DeKalb County Department of Planning & Sustainability

STAFF ANALYSIS

Case No.:	Z-19-1235291	Agenda #: N7
Location/ Address:	2080 Tilson Road, Decatur, Georgia	Commission District: 3 Super District: 6
Parcel ID:	15-140-04-011	
Request:	To rezone property from R-75 (Residential Medium Lot) to RSM (Small Lot Residential Mix) to allow the development of 20 single-family homes.	
Property Owner:	Greater White Rock Baptist Church	
Applicant/Agent:	VC Development LLC	
Acreage:	4.1 acres	
Existing Land Use:	Vacant land	
Surrounding Properties:	Single-family homes to the north and west; single-family homes and vacant land to the south across Tilson Road; and a church (Greater White Rock Baptist Church) and single-family homes to the east.	
Adjacent Zoning:	North: R-75 South: R-75 & RSM East: R-75 West: R-75	
Comprehensive Plan: SUB	Consistent <input checked="" type="checkbox"/>	Inconsistent <input type="checkbox"/>
Proposed Density: 4.76 units per acre	Existing Density: NA	
Proposed Units/Square Ft.: 20 single-family homes	Existing Units/Square Feet: Vacant

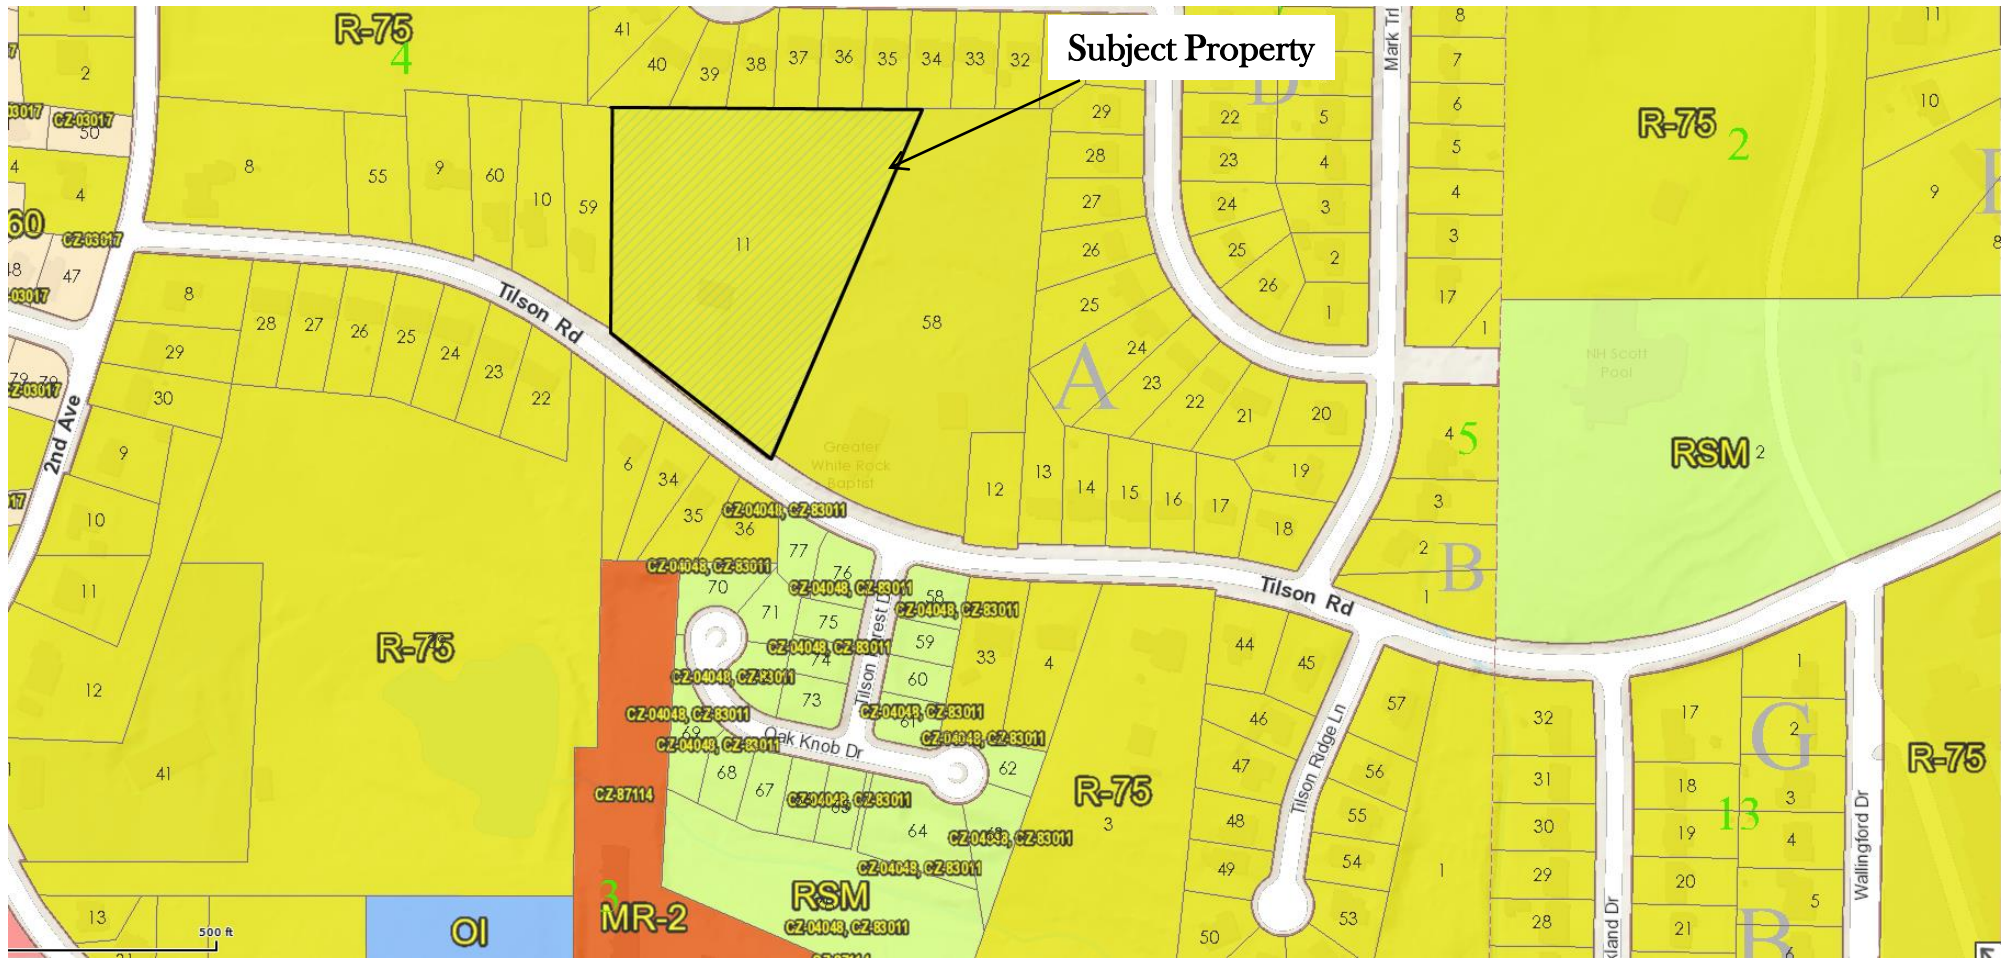
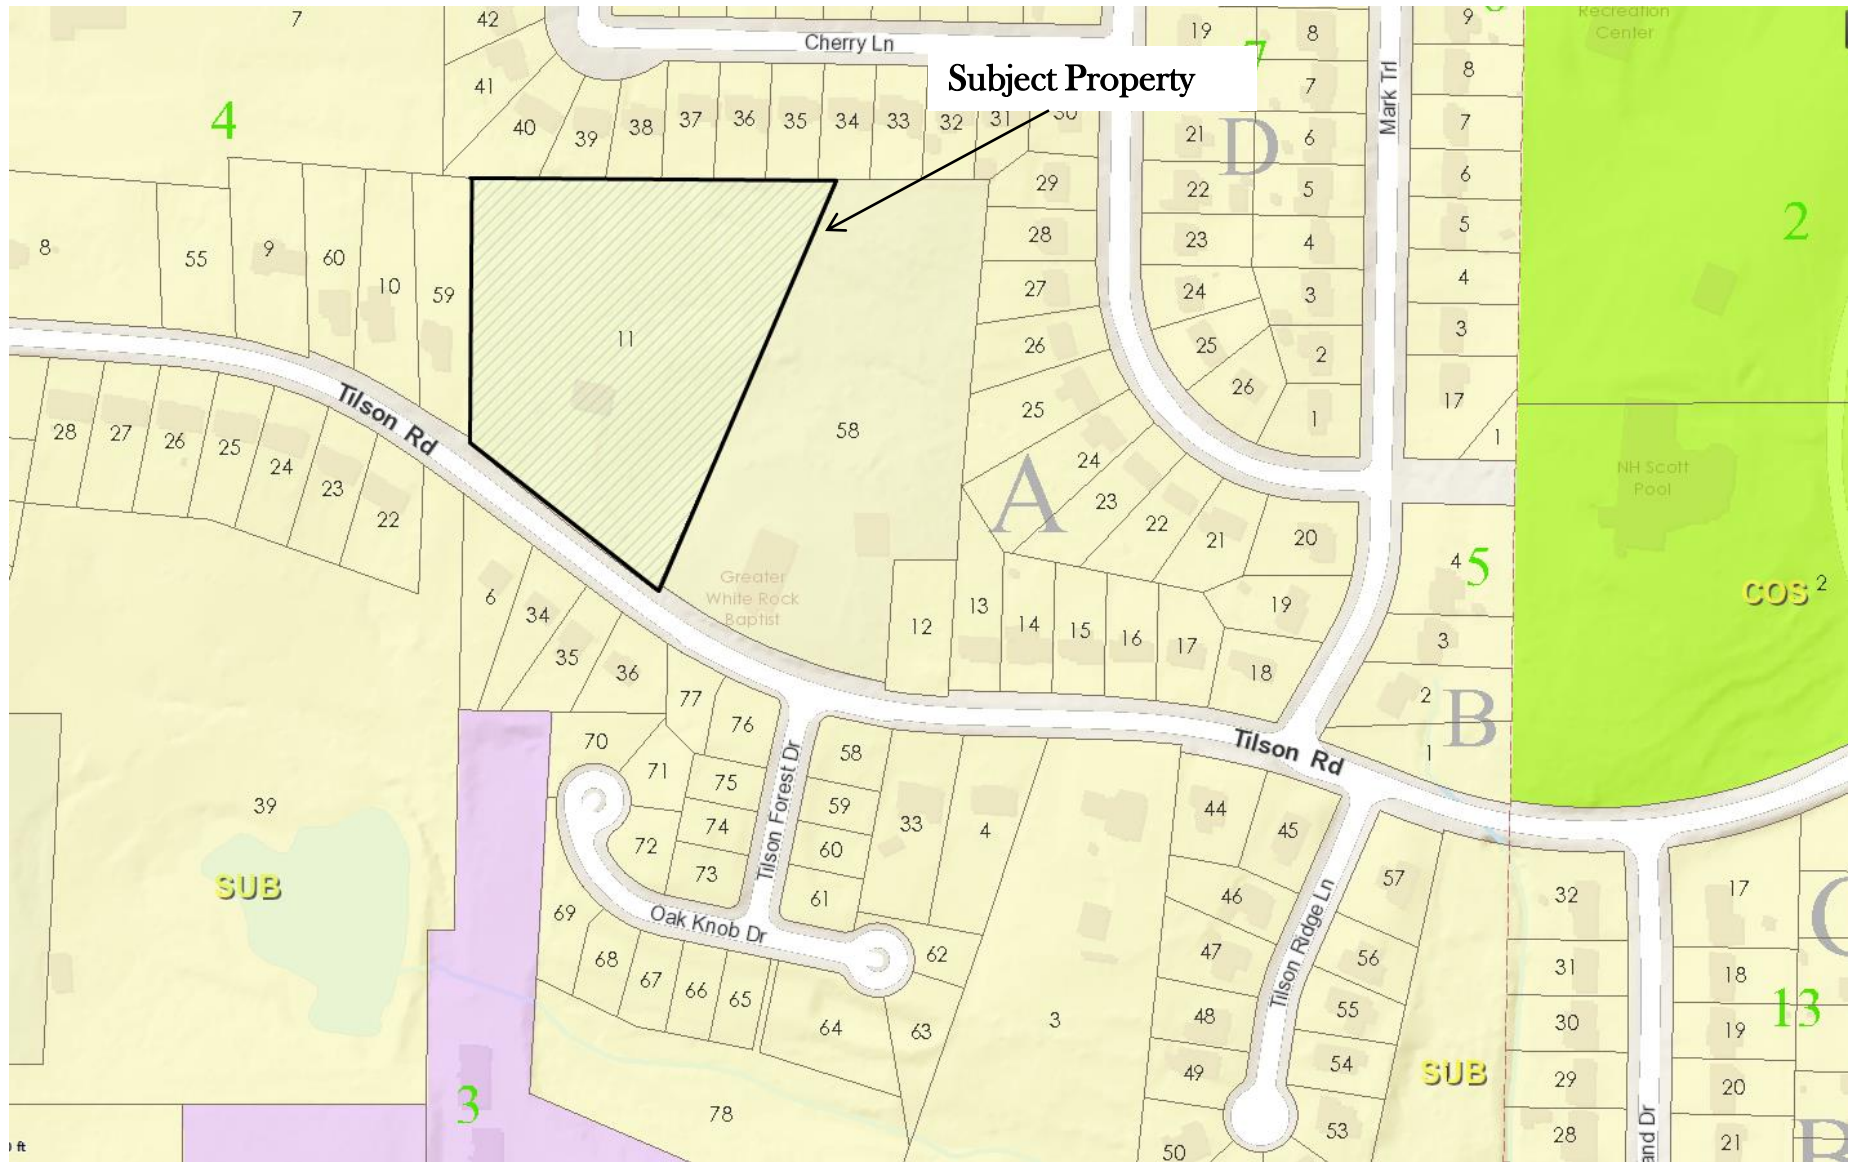
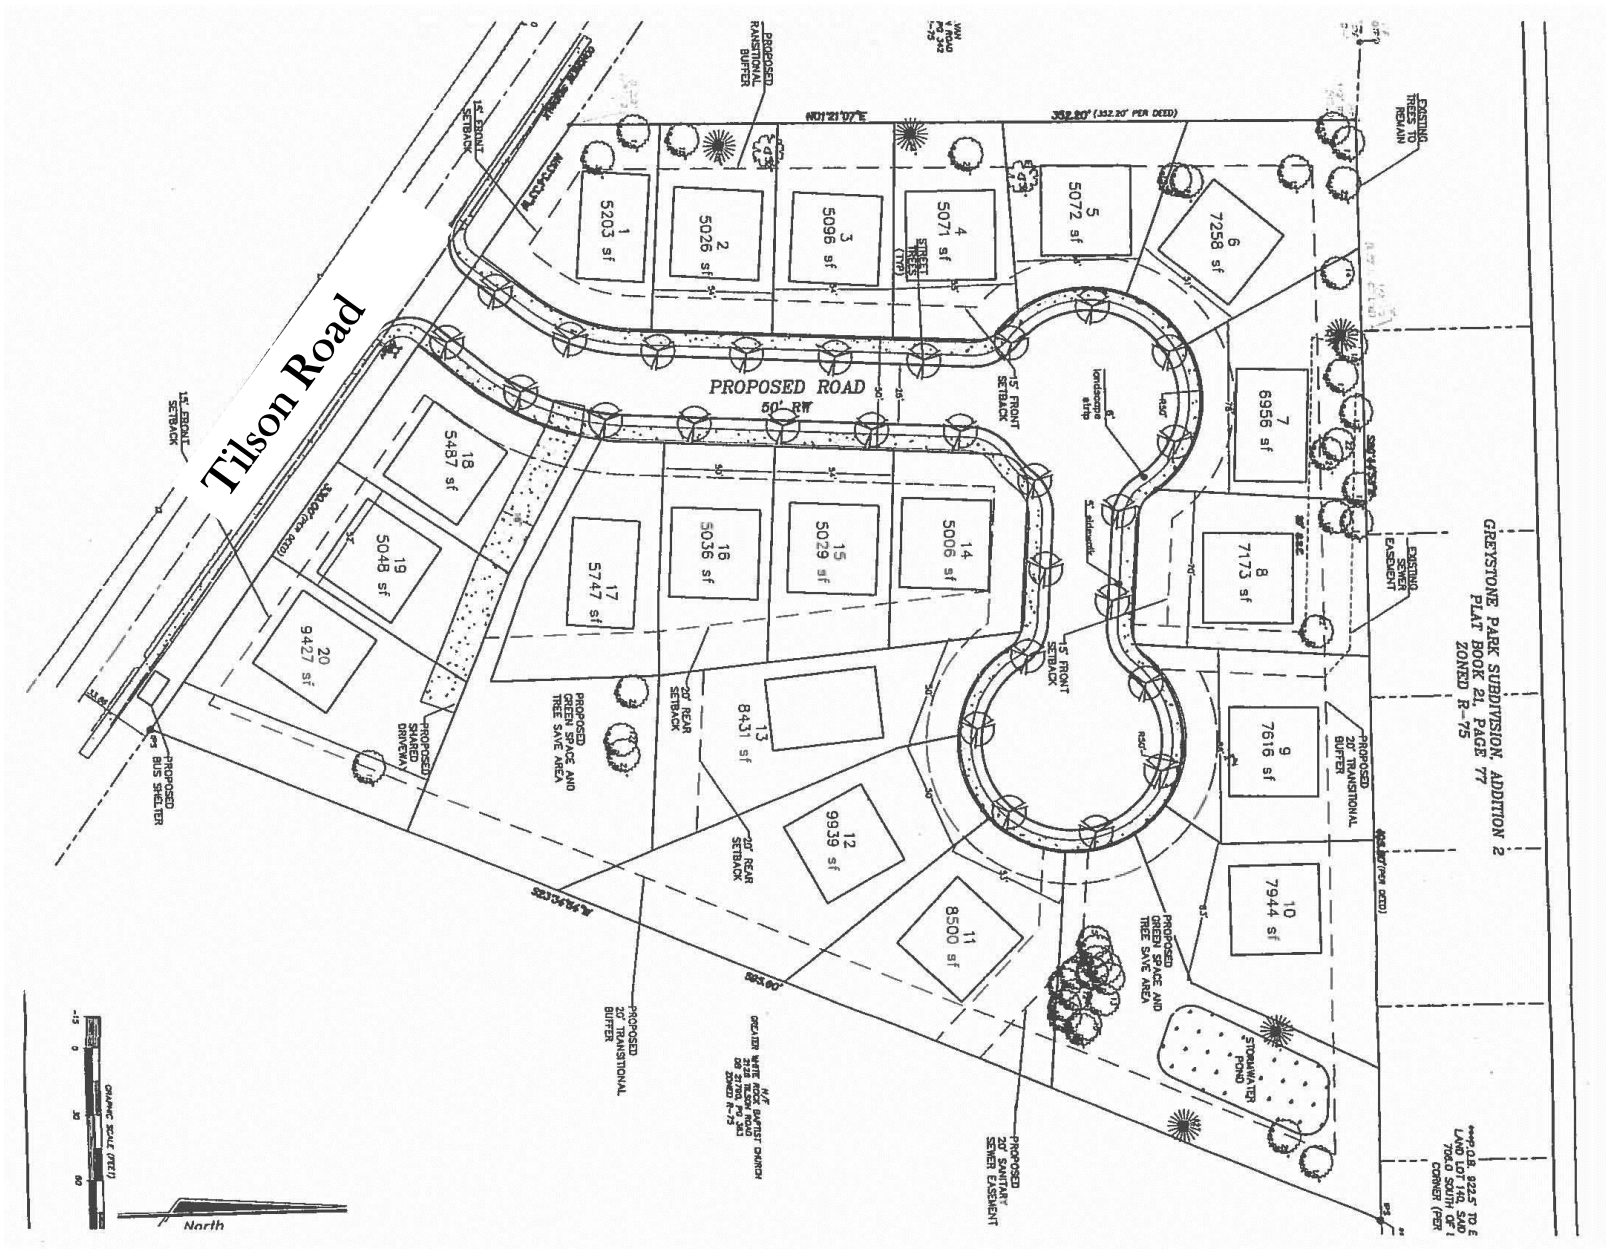
The proposed site plan is for 20 single-family homes, with two lots dedicated to detention and open space at a proposed density of 4.76 units per acre. To achieve a 20% density bonus of .76 units above 4 units per acre, the applicant is proposing to construct a bus shelter along Tilson Road. The applicant has indicated that they will provide documentation that MARTA has approved the location of the bus station as soon as they receive confirmation. The proposed single-family subdivision will be accessed via one new public right-of-way off of Tilson Road. The proposed layout includes a "double cul de sac". Sidewalks and street trees are proposed along both sides of the proposed street. All proposed lots will contain a minimum of 5,000 square feet and a minimum of 50 feet of lot width as required by the Zoning Ordinance. Based on the submitted site plan, however, the proposed double cul-de-sac layout may not be in compliance with Transportation design requirements. Additionally, for the lots along the northern property line, the site plan does not indicate if those lots comply with the zoning ordinance requirements to be at least 80% as wide and as large as the abutting subdivision lots. Given these issues, RSM zoning and higher residential densities may be appropriate for the project site, but it does not appear that the proposed site plan demonstrates compatibility with surrounding properties. Therefore, approval cannot be based on the submitted site plan.

STANDARD	REQUIRED	EXISTING/PROVIDED	COMPLIANCE
LOT WIDTH Sec.27-186(a)	50 ft	50 feet	Yes
LOT AREA Sec.27-186(b)	5,000 s.f. per lot	5,000 s.f.	Yes
FRONT SETBACK Sec.27-186(c)(4)	20 Feet	15 Feet	No <i>(will need to revise plan to comply or obtain variance from BZA)</i>
PERIMETER LOT COMPATIBILITY	Lots along North property line must be at least 80% as wide and large as abutting lots	Not Shown	Undetermined
INTERIOR SIDE YARD SETBACK Sec.27-186(d)	3 ft with 10 ft between buildings	3 ft with 10 ft between buildings	Yes Yes
REAR SETBACK Sec.27-186(e)	20 Feet	20 Feet	Yes
TRANS. BUFFERS	20 ft	20 ft	Yes
BUILDING HEIGHT Sec.27-187	35 ft	35 ft	Yes
OPEN SPACE	None required since less than 5 acres and 36 units	10,000 sf (approx.) on 2 lots	Yes
MAX LOT COVERAGE	50%	50%	Yes
MIN UNIT SIZE	1,200 sf	1,200 sf	Yes
PARKING Sec. 27-150 (e)	2 spaces per lot	Not Shown	Undetermined

N7. Refer to Section 14-190 of the Land Development Code and Chapter 5.4.3 of the Zoning Code for infrastructure requirements. Tilson Road is classified as a collector street. Right of way dedication of 35 feet from centerline, 6 foot sidewalks, street lights, bike lanes required. Verify driveway placement to ensure required sight distance requirements are met based on the speed limit and curvature of roadway. Interior streets to be local- 55 foot right of way, five foot landscape strip, 5 foot sidewalk, street lights required.

1. Site shall be zoned RSM to develop up to a maximum of 20 single-family homes, provided condition #2 is satisfied. Otherwise, density capped at 4 **d.u.** per acre.

2. Written verification from MARTA that the location and design of the proposed bus shelter is approved. Proposed bus shelter facility shall include at a minimum a shelter structure, bench and paved access and be designed according to MARTA or GRTA standards, based upon ridership thresholds and as documented as acceptable by either agency.

3. Show compliance with Sec. 5.2.3 of the Zoning Ordinance (Perimeter Lot Compatibility with existing subdivisions) for the proposed lots along the north property line which abut existing single-family residential lots.

4. Show compliance with Table 5.1 regarding 10-foot landscape strip and 6-foot-wide sidewalk as well as street trees spaced 40 feet apart along Tilson Road subject to approval by the County Arborist.

5. Show a pedestrian path connecting public sidewalk to green space/open space.
6. Provide documentation of mandatory Homeowners Association to maintain common open space.

7. Compliance with Article 5 regarding provision of architectural variability of facades, façade offsets, garage widths and setbacks, and porch/stoop dimensions.
